Subject: Docket 71-9036; Response to Request for Additional Information
Consolidated Application to Certificate of Compliance
SPEC Model C-1 Transportation Package
Package Identification Number USA/9036/B(U)

**CONSOLIDATED APPLICATION
for
NRC CERTIFICATE OF COMPLIANCE
USA/9036/B(U)**

**Model SPEC C-1
Type B(U) Radioactive Material Package**

SOURCE PRODUCTION & EQUIPMENT CO INC 113 TEAL ST. ST ROSE LA 70087	SIZE C	DWG NO B322000	REV 1
APPROVED <i>[Signature]</i> 2/28/01	SCALE: 3/8	00108501	SHEET 3 OF 3

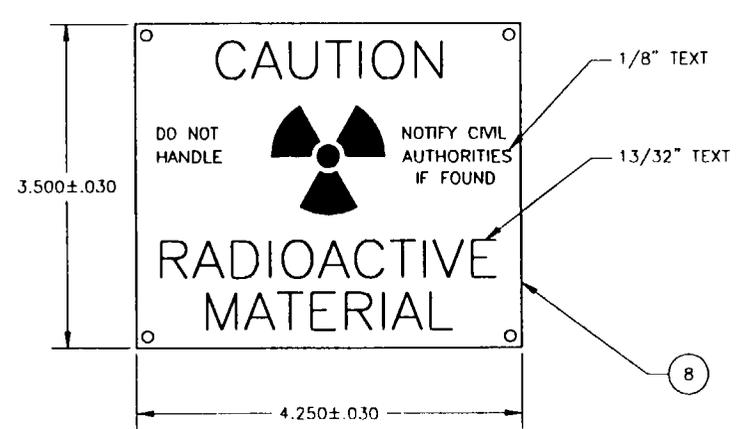
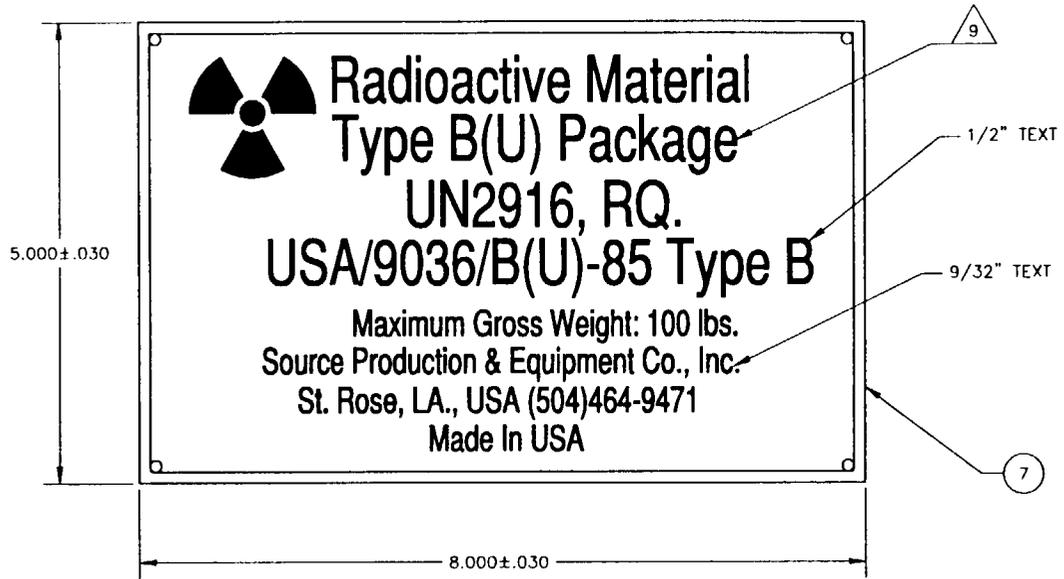
Drawing B322000: Added depiction of the nameplate and trefoil and their locations on the overpack.

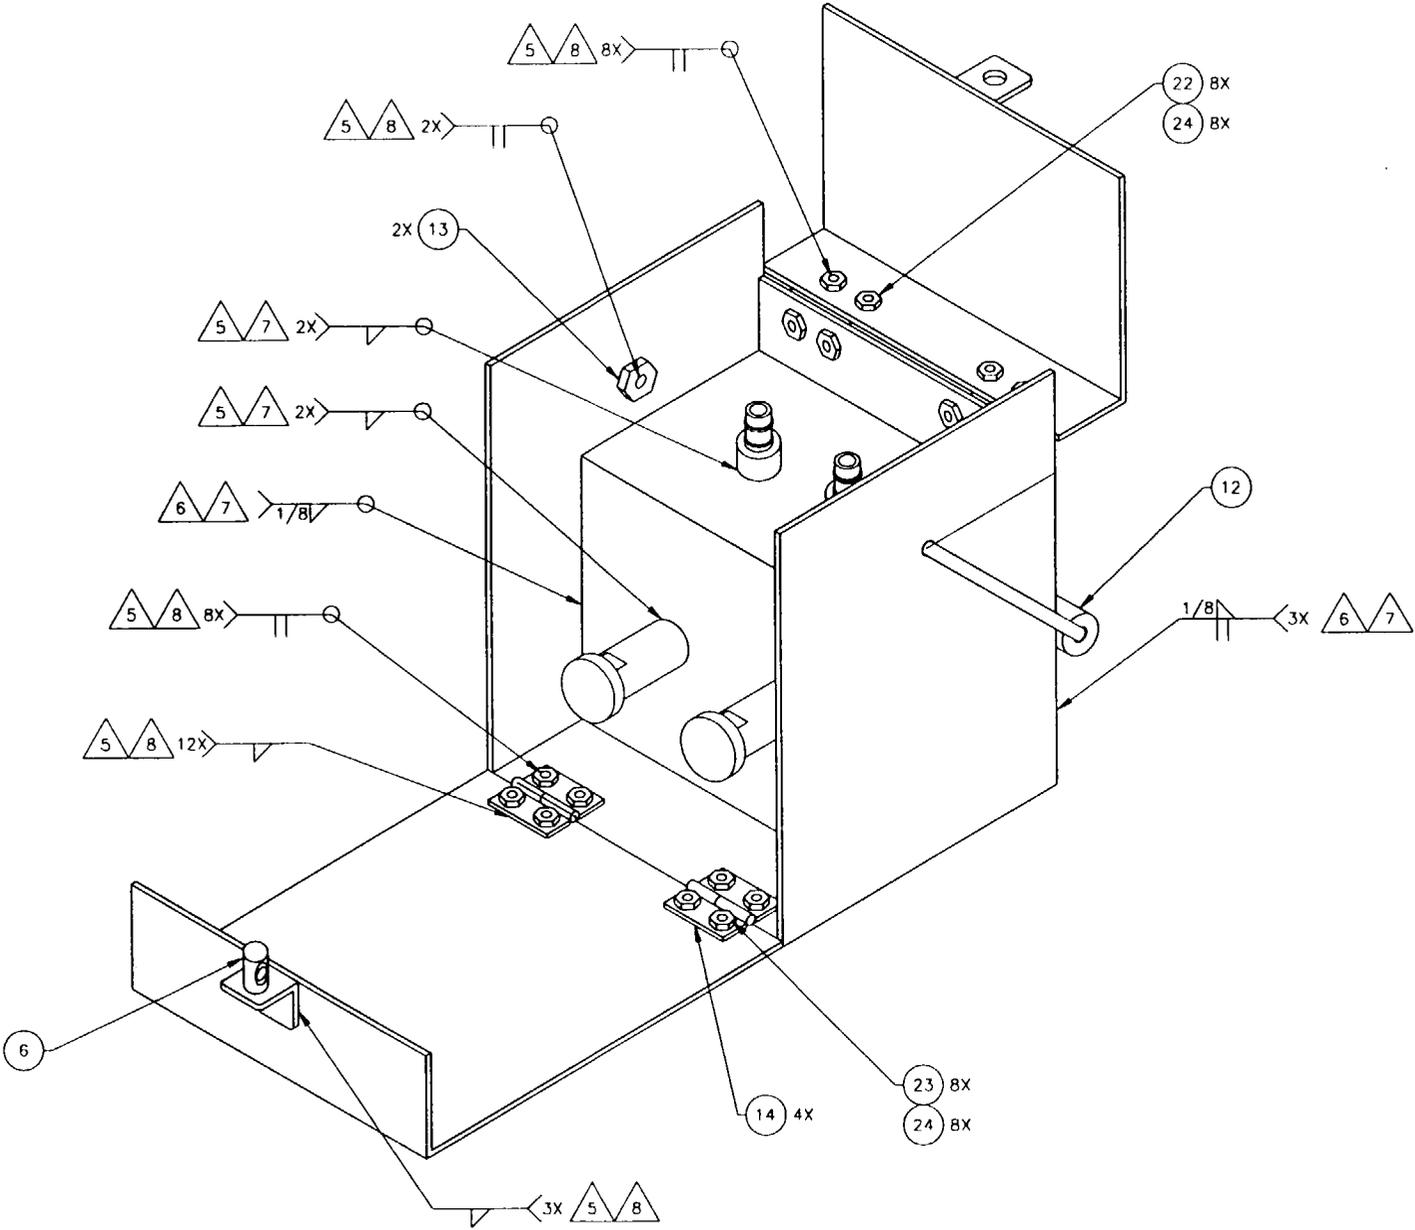
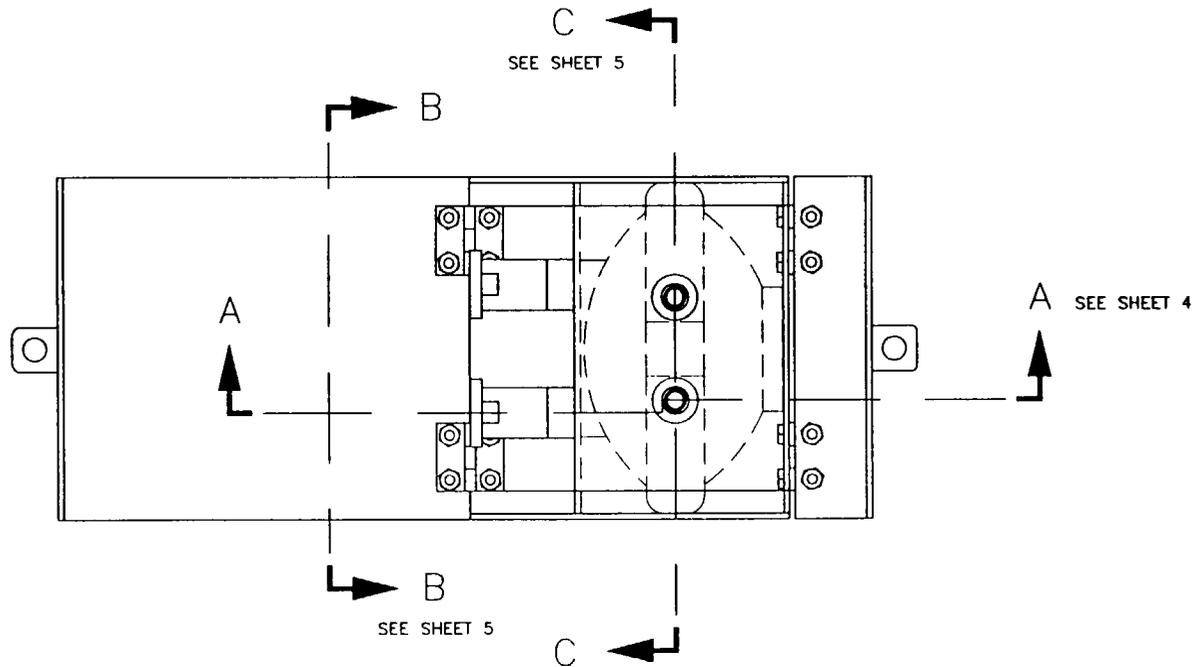
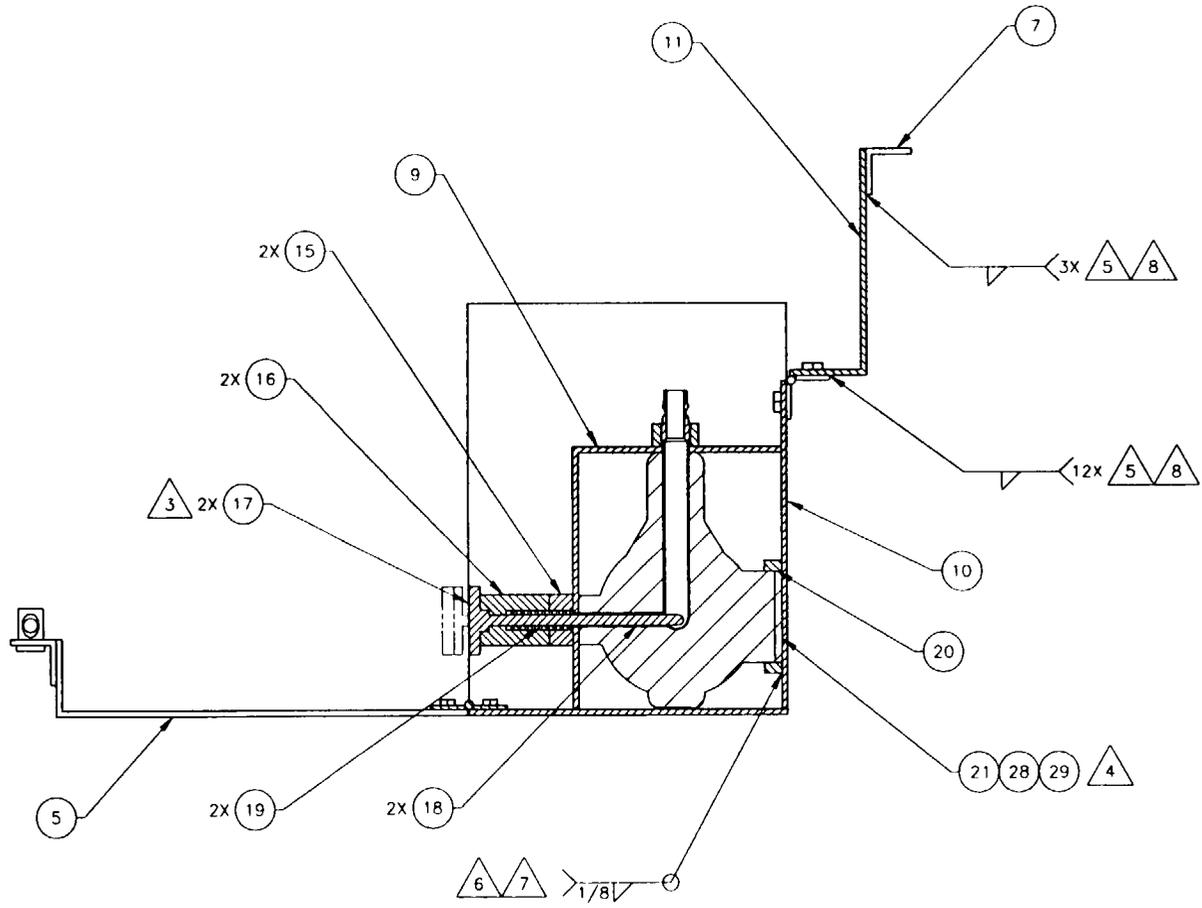
Drawing B311000: Added identification of the materials of construction for all panels and doors, weld specifications, examination standards, weight (from drawing B322000). Moved overall dimensions to drawing B311002.

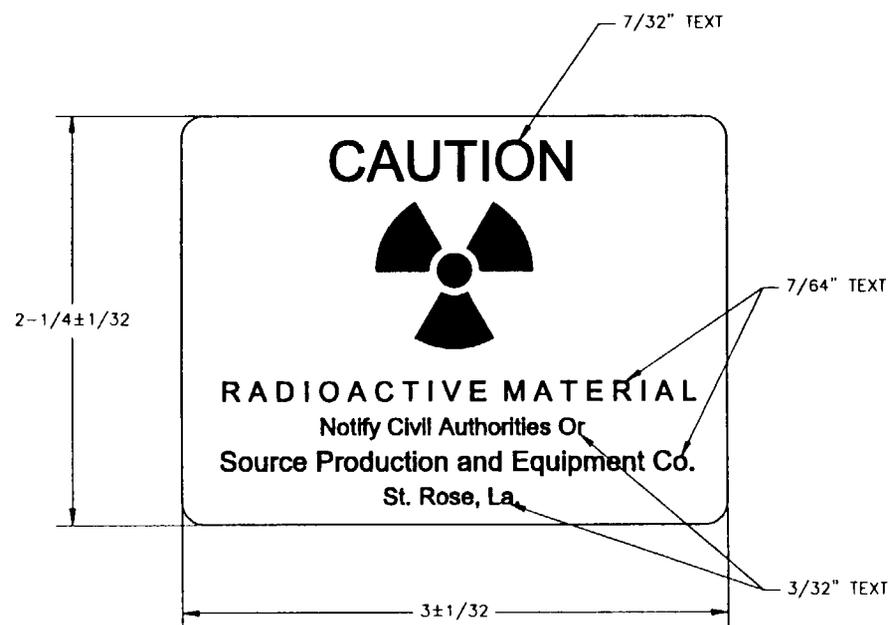
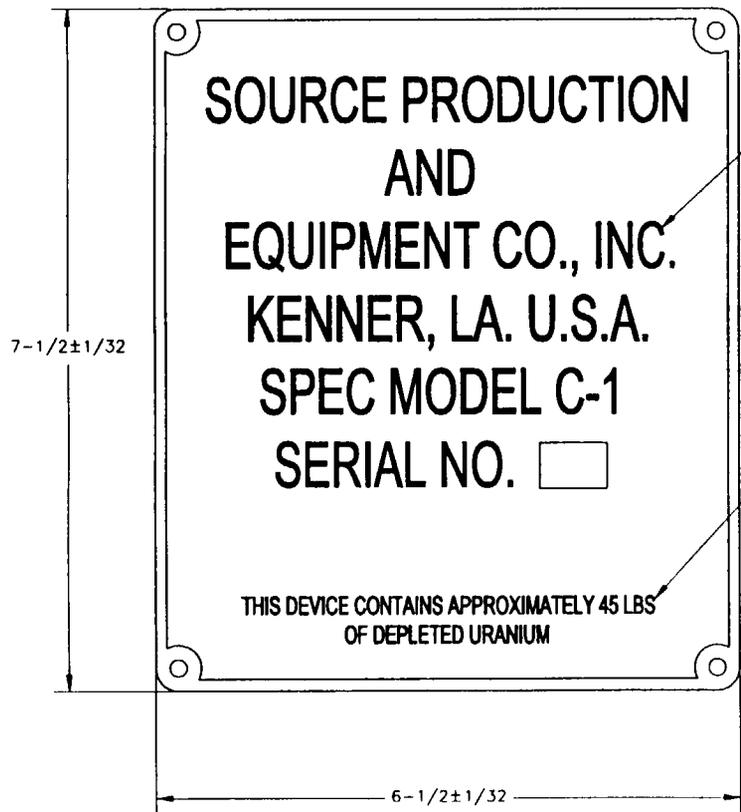
Drawing B311002: This drawing was added to describe the C-1 nameplate and trefoil, and their installation on a C-1 Shipping Container. Added overall dimensions from drawing B311000.
